Vertex Innovative Apparels Ltd. (10524)

Forkan Tower, 360/A, Bitak Bazar, Sagorika, Pahartoli Thana, Chittagong

15.MARCH.2014

COLUMN SCHEDULE.

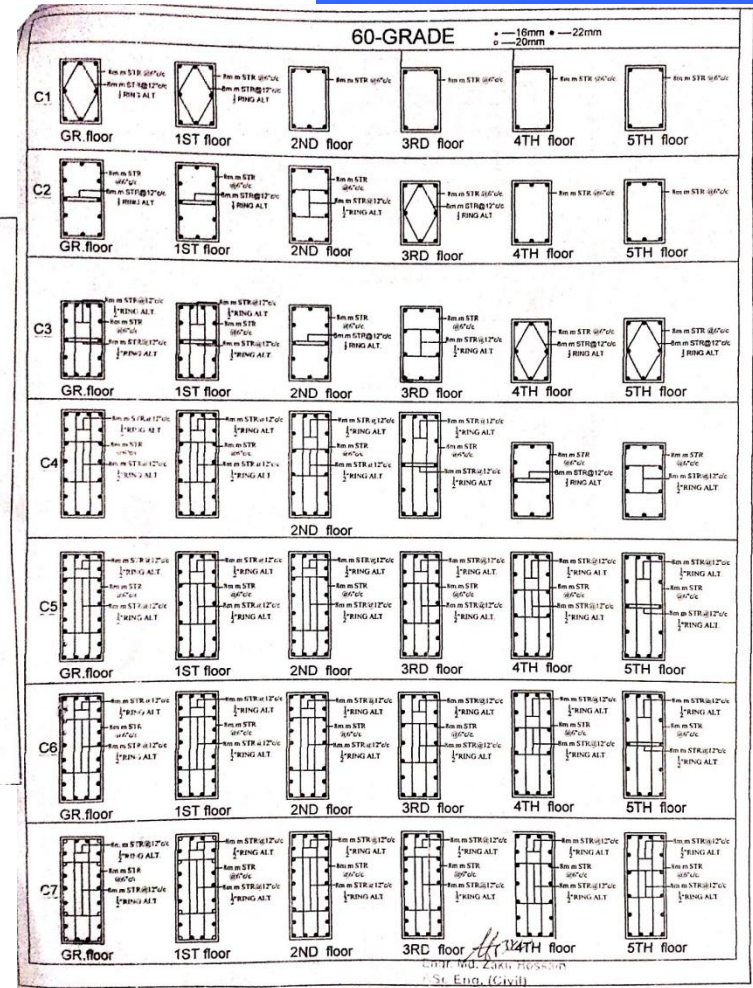
Low Column Safety Factors

Column load run-downs indicate lower than desirable column safety factors.

PAGE - 11

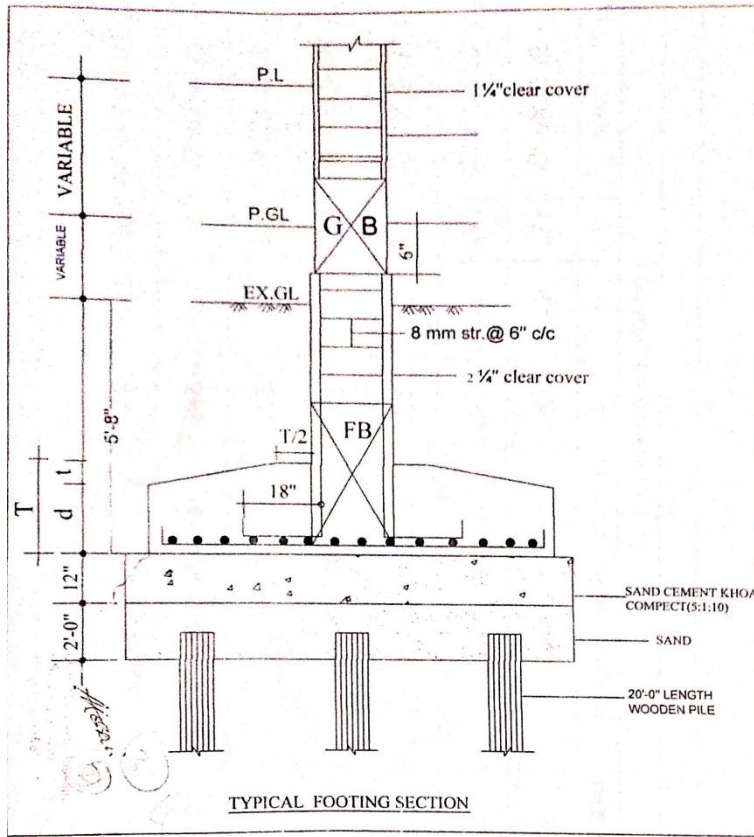
Soil Capacity/Footing Design & Incomplete Structural Drawings

Foundations are built in a manner other than that recommended by the geotechnical report. General foundation capacity checks were performed. Based upon Geotechnical findings, the soil bearing capacity does not appear adequate to support the foundation shown on the structural drawings.

Incomplete Structural Drawings

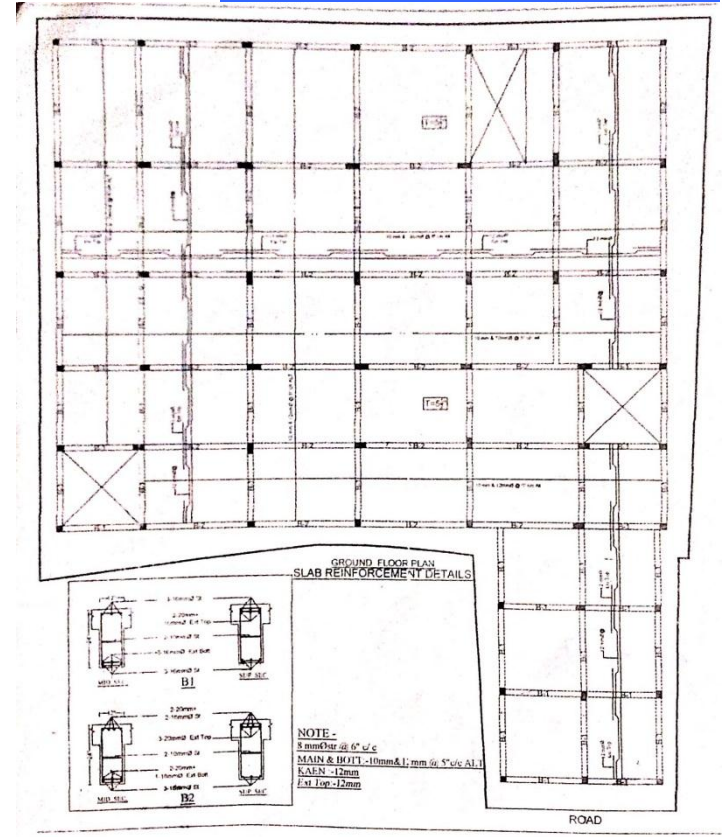
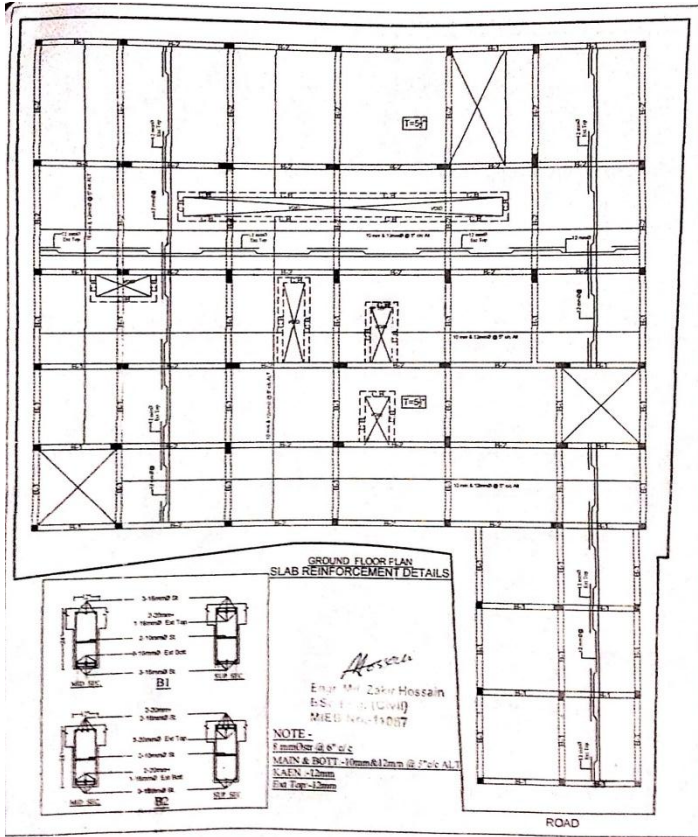
Structural drawings are incomplete. Typical slab reinforcing and roof slab reinforcing plans are missing. Two differing ground floor slab plans are presented. Plans are generally of very poor quality.
